Addendum No. 2

Date:	May 30, 2013
To:	Contractors
From:	Rick James - Project Manager
Reference:	George S. Eccles Student Life Center University of Utah – Salt Lake City, Utah DFCM Project No. 08015750
Subject:	**Addendum No. 2**

2.2 **GENERAL ITEMS**: See attached Architect's Addendum No. 1 dated May 28, 2013.

1 EP100.B B ENLARGED LOWER LEVEL POWER PLAN SOUTH
SCALE |1/8" = 1'-0"

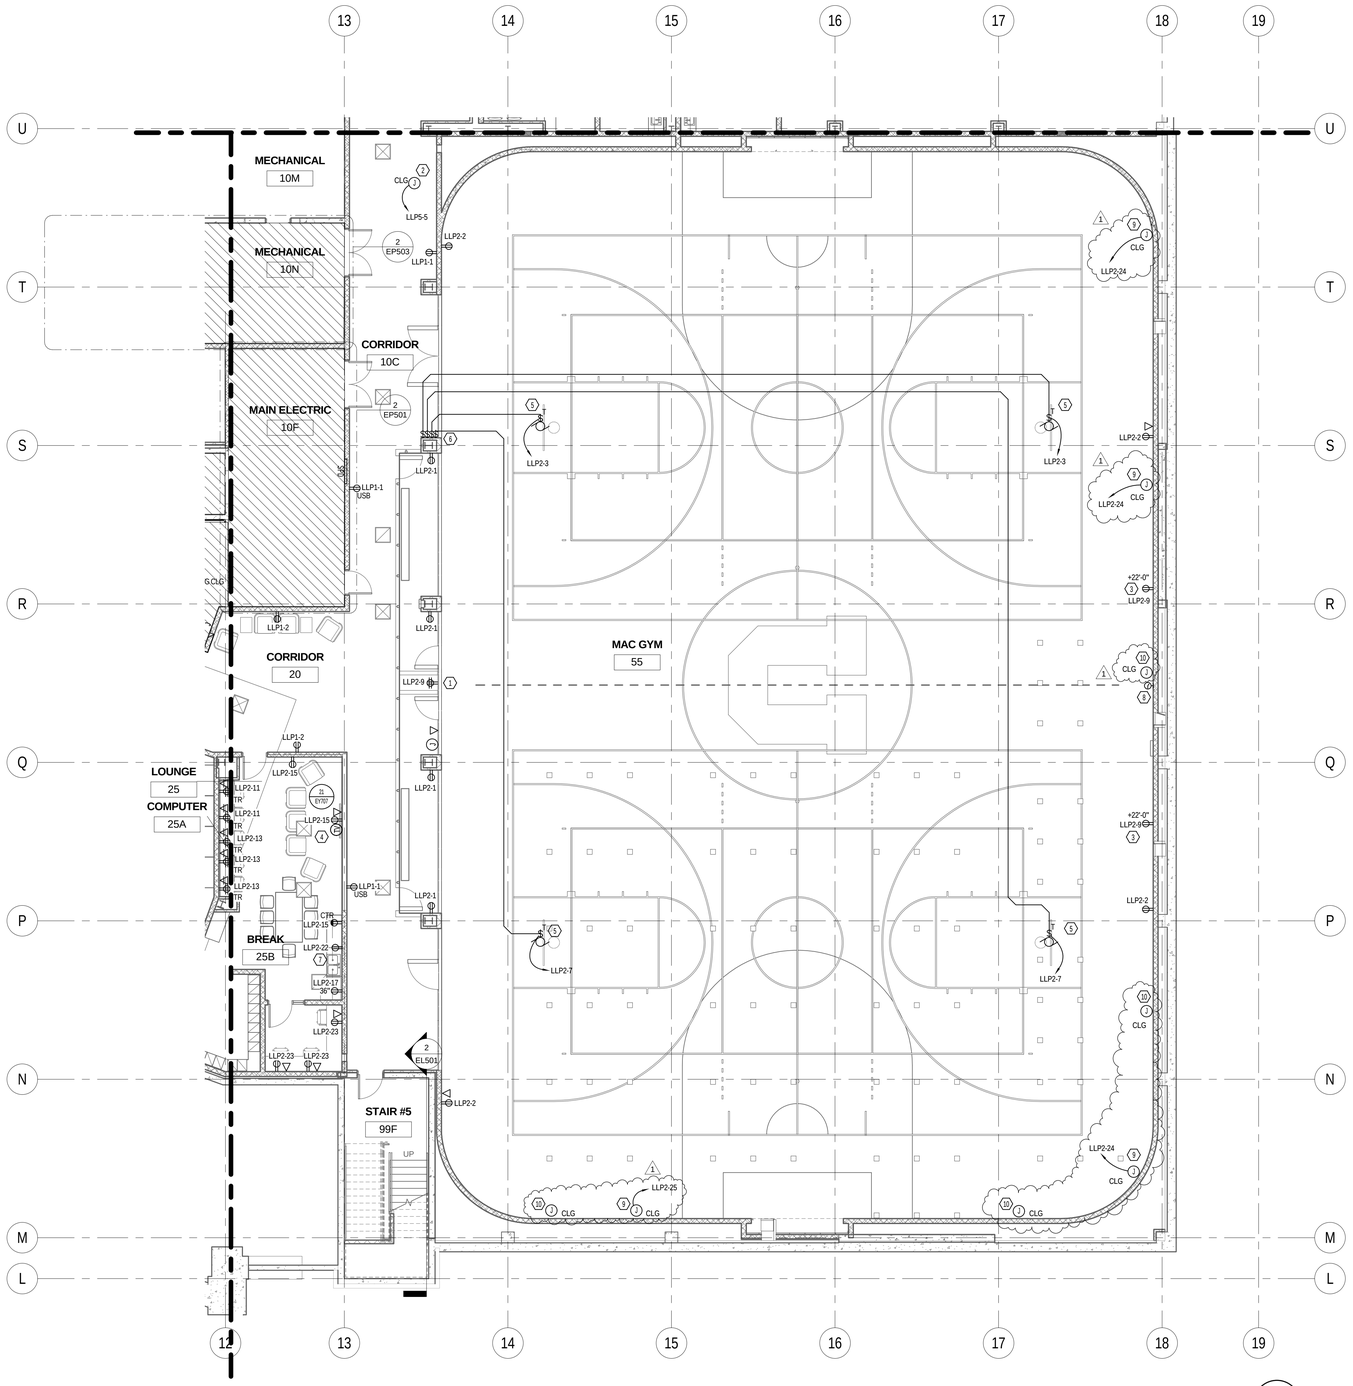
1. Add: Keyed Note #9 – See attached sheet EP100.B
2. Add: Keyed Note #10 – See attached sheet EP100.B
3, Add: Junction boxes in various locations for motorized shades and future motorized shades. See attached sheet EP100.B for locations.

1 A ENLARGED LEVEL 1 POWER PLAN NORTH
EP101.A SCALE [1/8" = 1'-0"

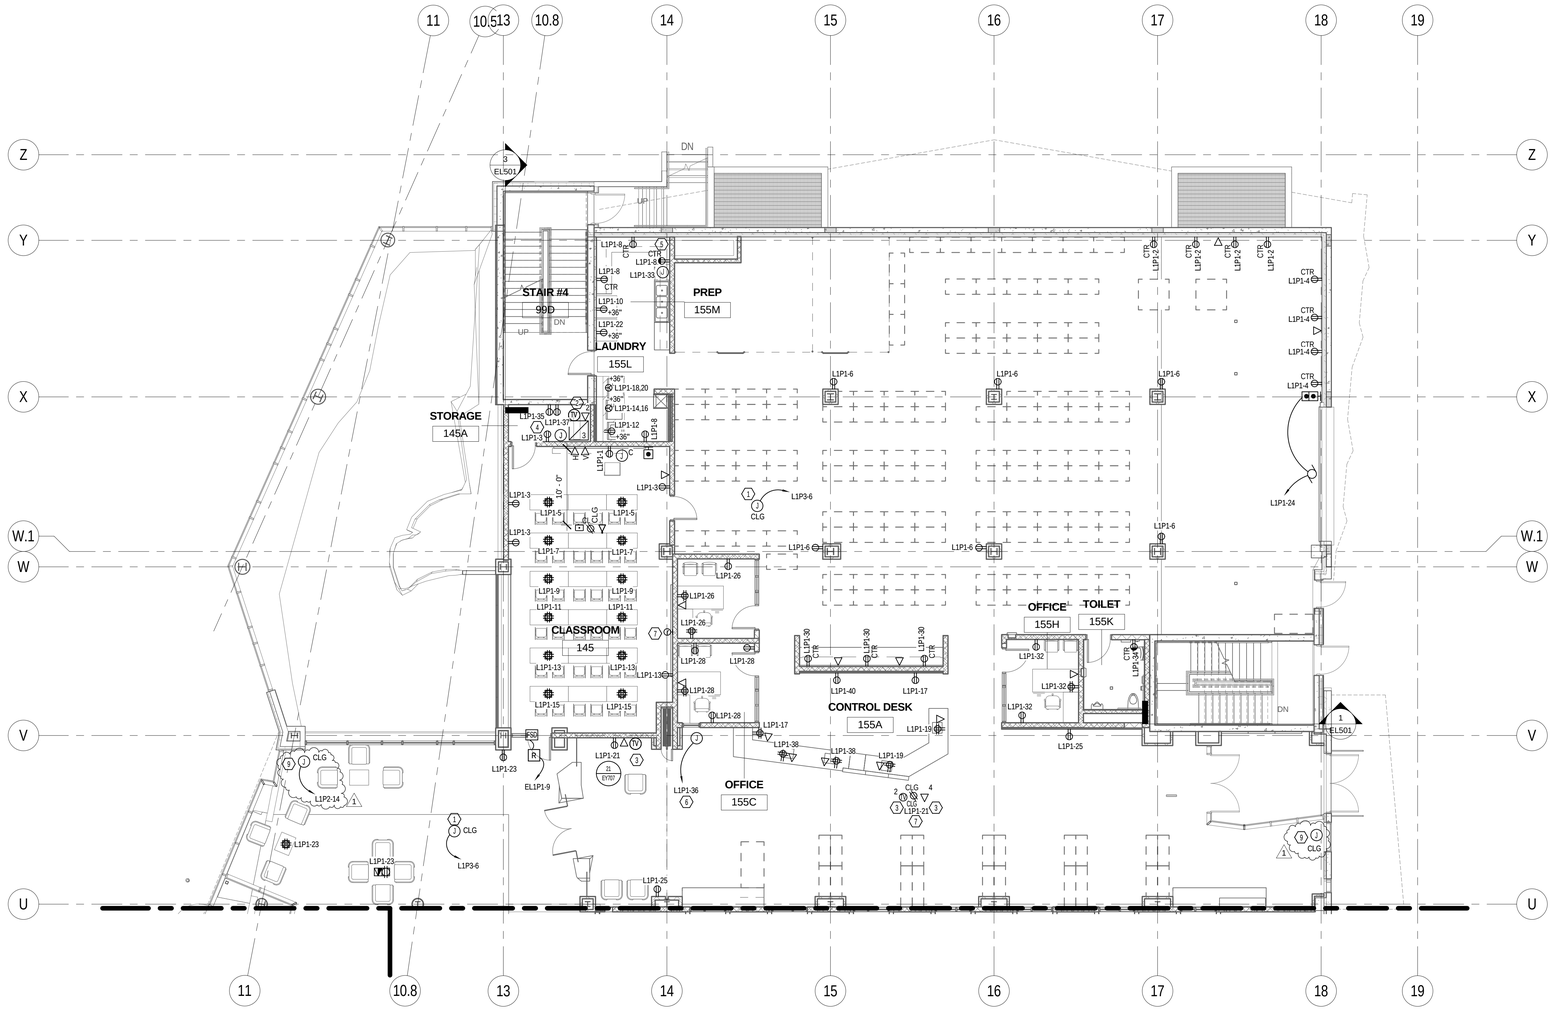
1. Add: Keyed Note #8 – See attached sheet EP101.A
2. Add: Keyed Note #9 – See attached sheet EP101.A
3. Add: Junction boxes in various locations for motorized shades and future motorized shades. See attached sheet EP101.A for locations.

1 EP101.C C ENLARGED LEVEL 1 POWER PLAN WEST
SCALE | 1/8" = 1'-0"

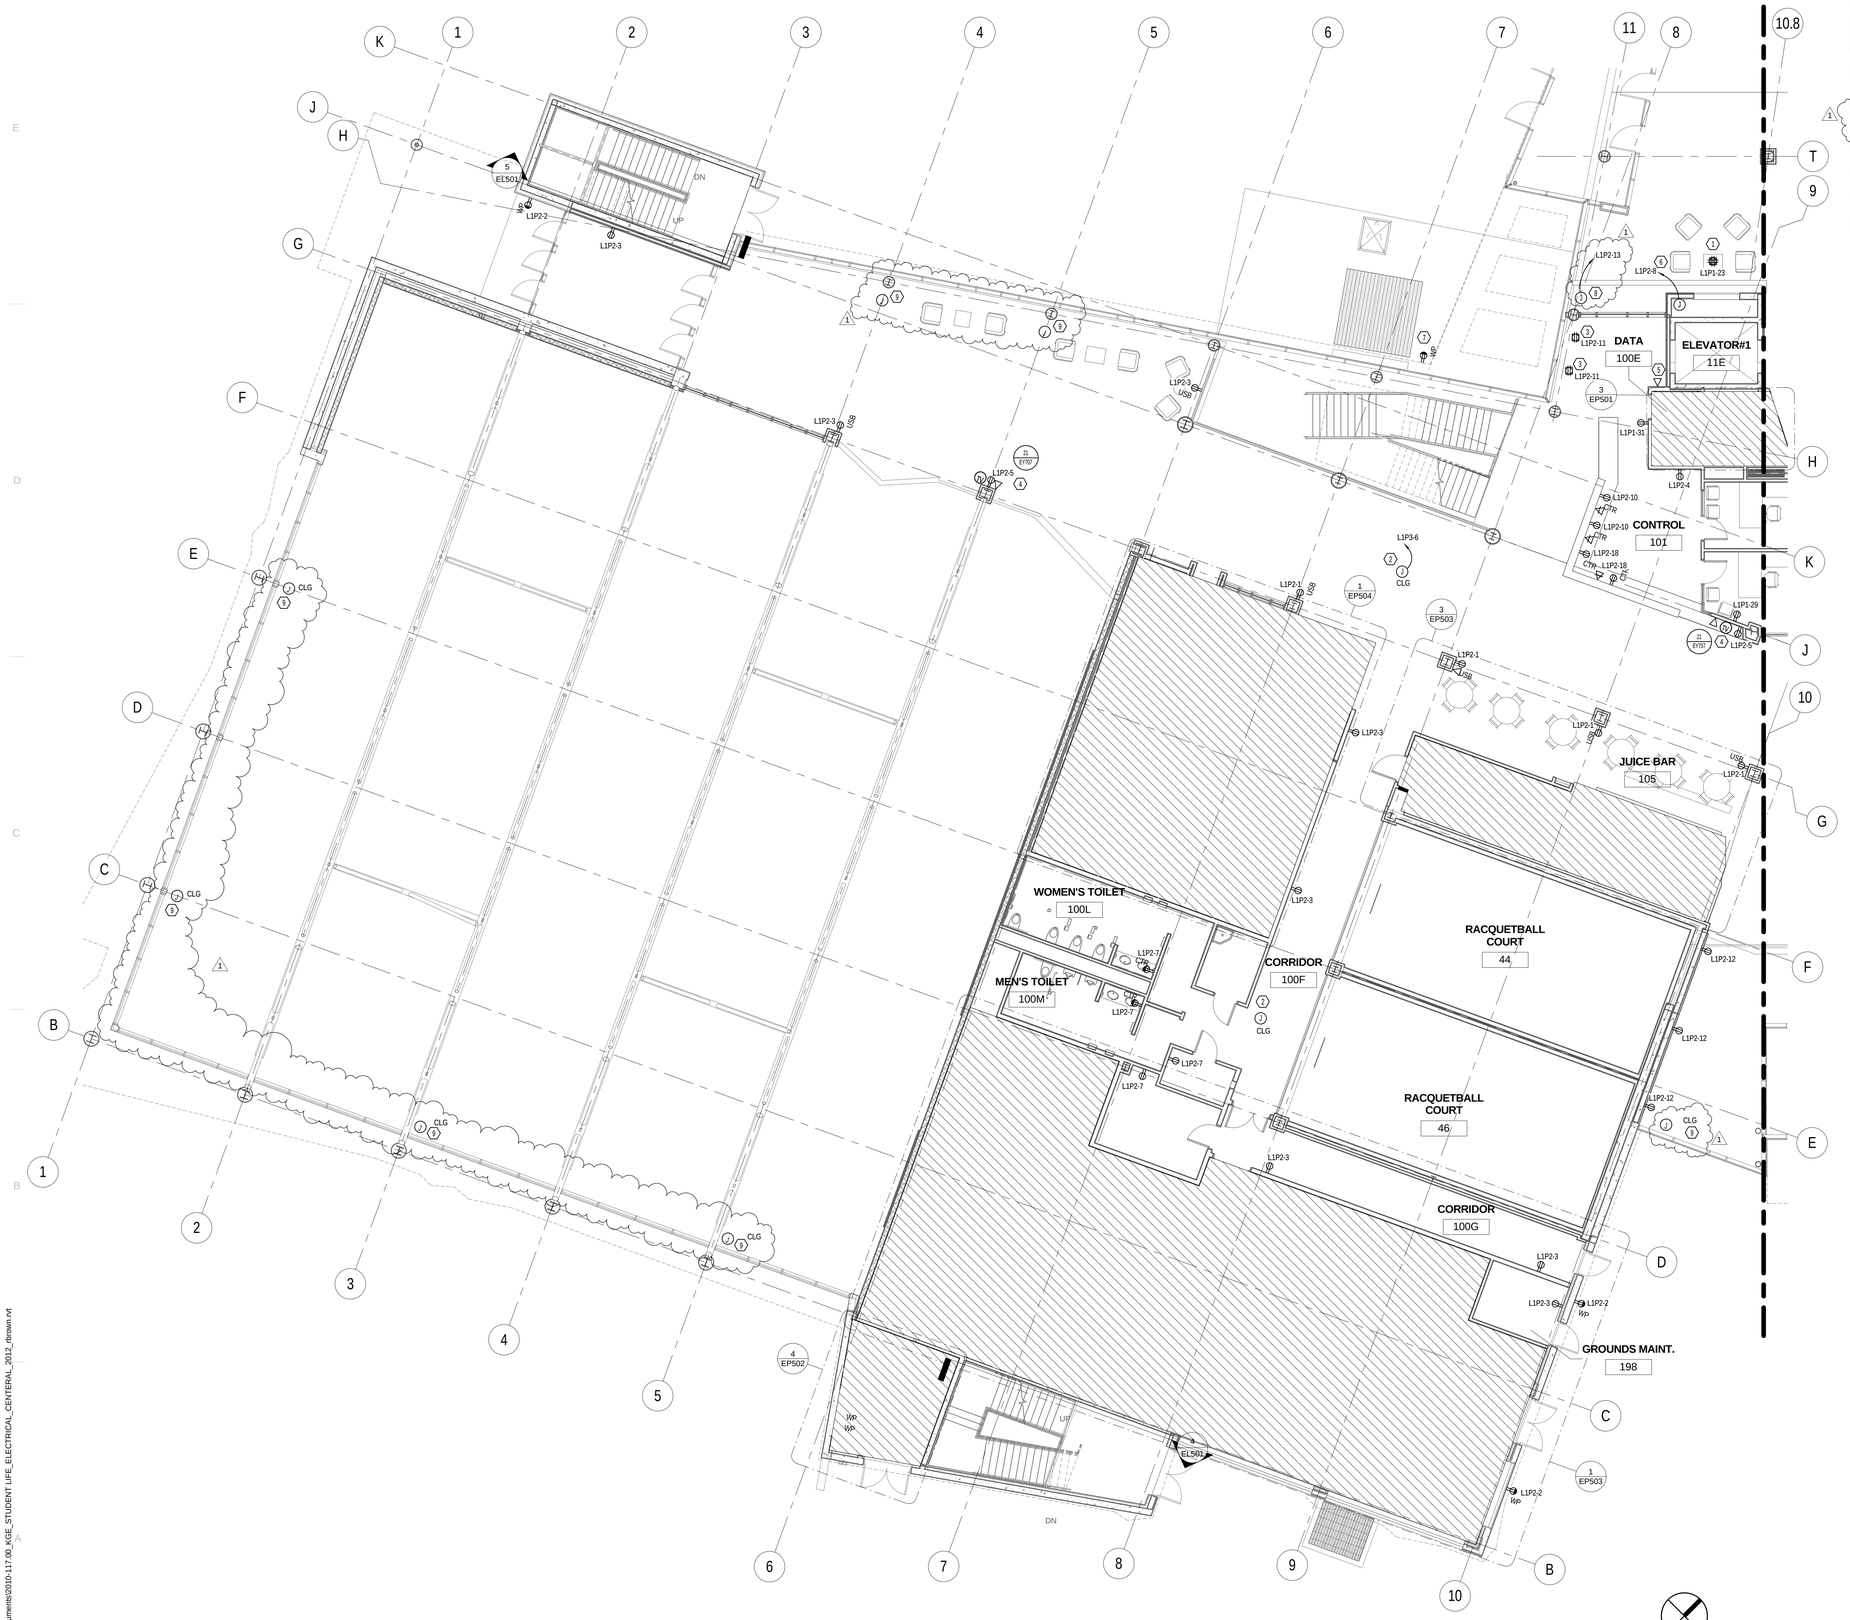
1. Add: Keyed Note #8 – See attached sheet EP101.C
2. Add: Keyed Note #9 – See attached sheet EP101.C
3. Add: Junction boxes in various locations for motorized shades and future motorized shades. See attached sheet EP101.C for locations.

1 EP102.A A ENLARGED LEVEL 2 POWER PLAN NORTH
SCALE |1/8" = 1'-0"

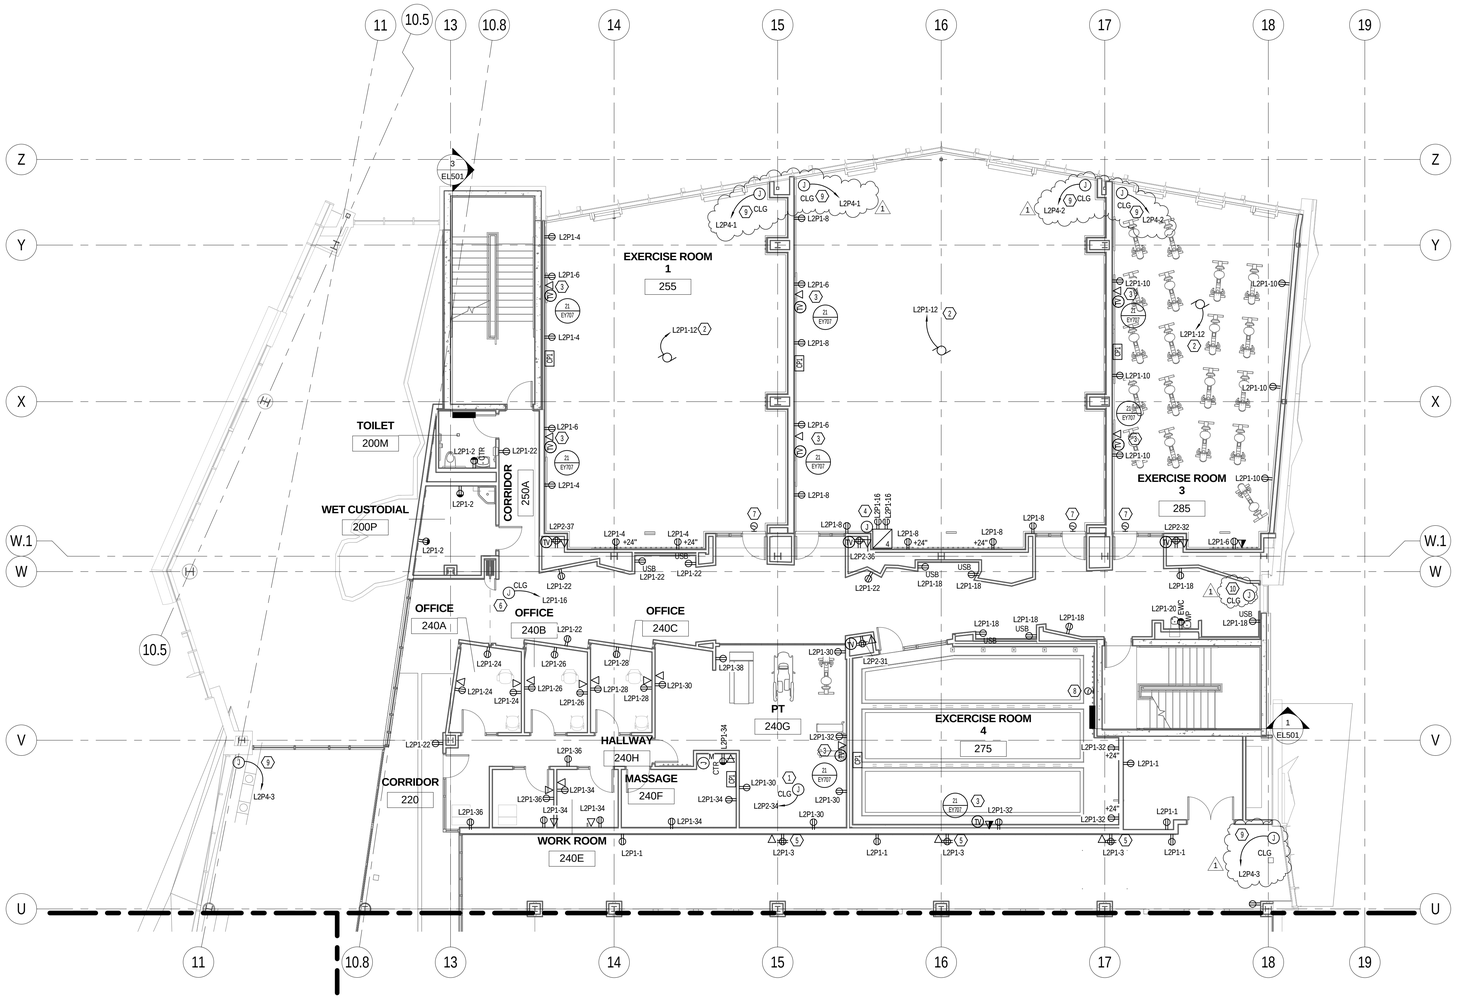
1. Add: Keyed Note #9 – See attached sheet EP102.A
2. Add: Keyed Note #10 – See attached sheet EP102.A
3. Add: Junction boxes in various locations for motorized shades and future motorized shades. See attached sheet EP102.A for locations.

1 B ENLARGED LEVEL 2 POWER PLAN SOUTH
EP102.B SCALE | 1/8" = 1'-0"

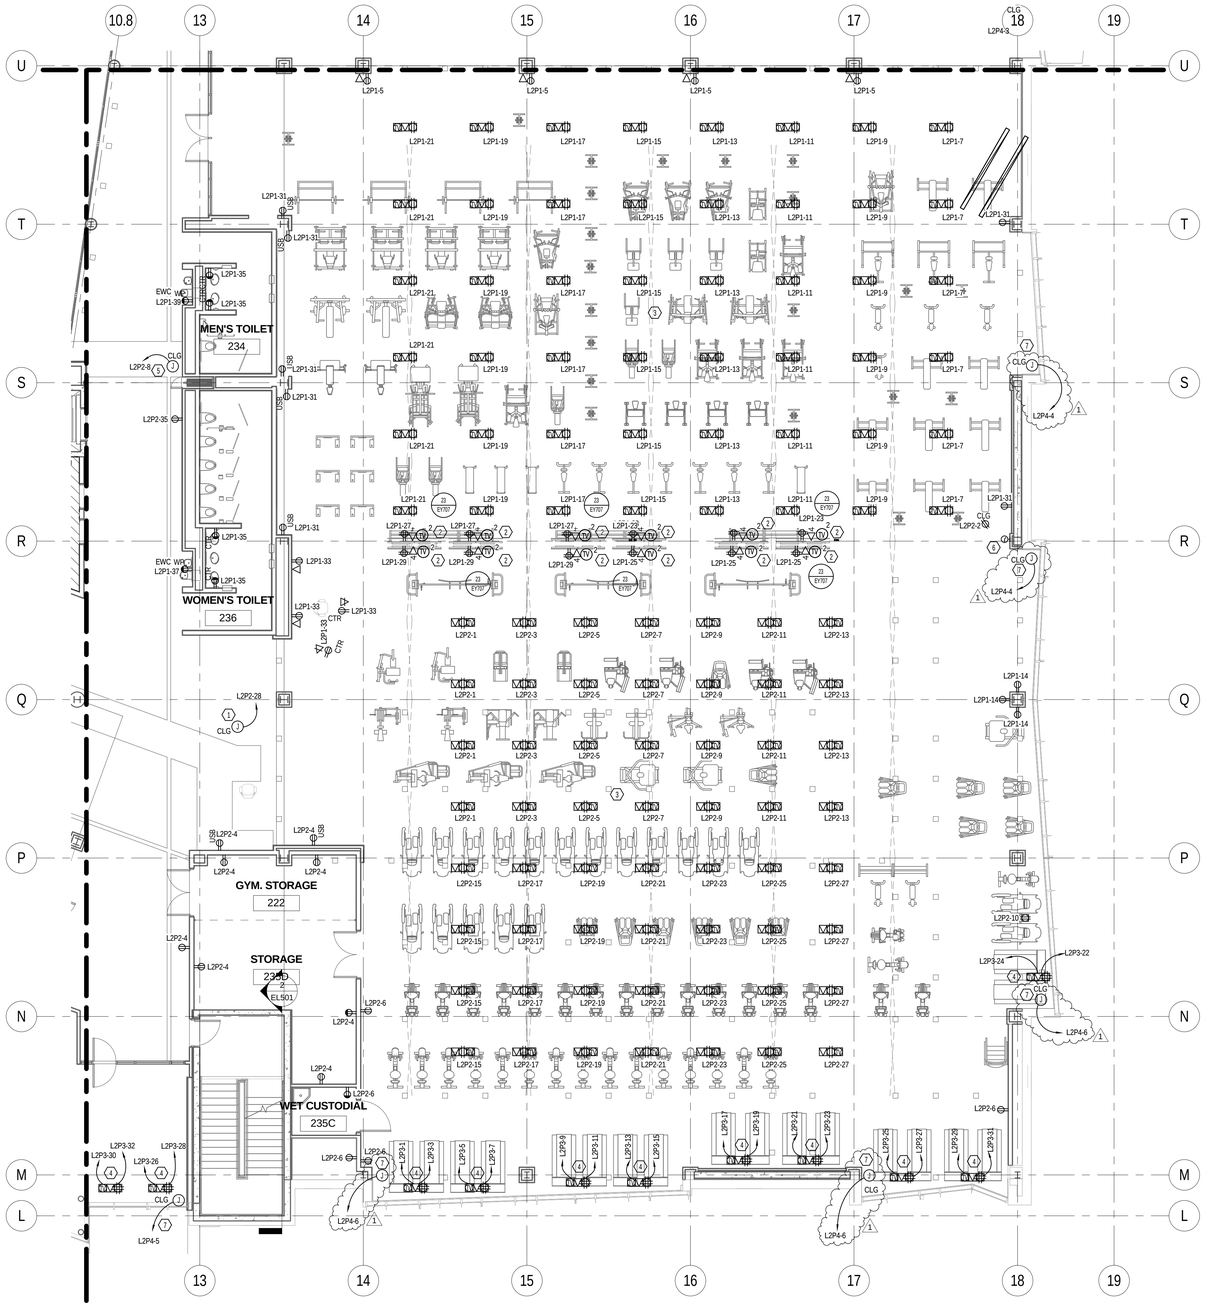
1. Add: Keyed Note #7 – See attached sheet EP102.B
2. Add: Keyed Note #8 – See attached sheet EP102.B
3. Add: Junction boxes in various locations for motorized shades and future motorized shades. See attached sheet EP102.B for locations.
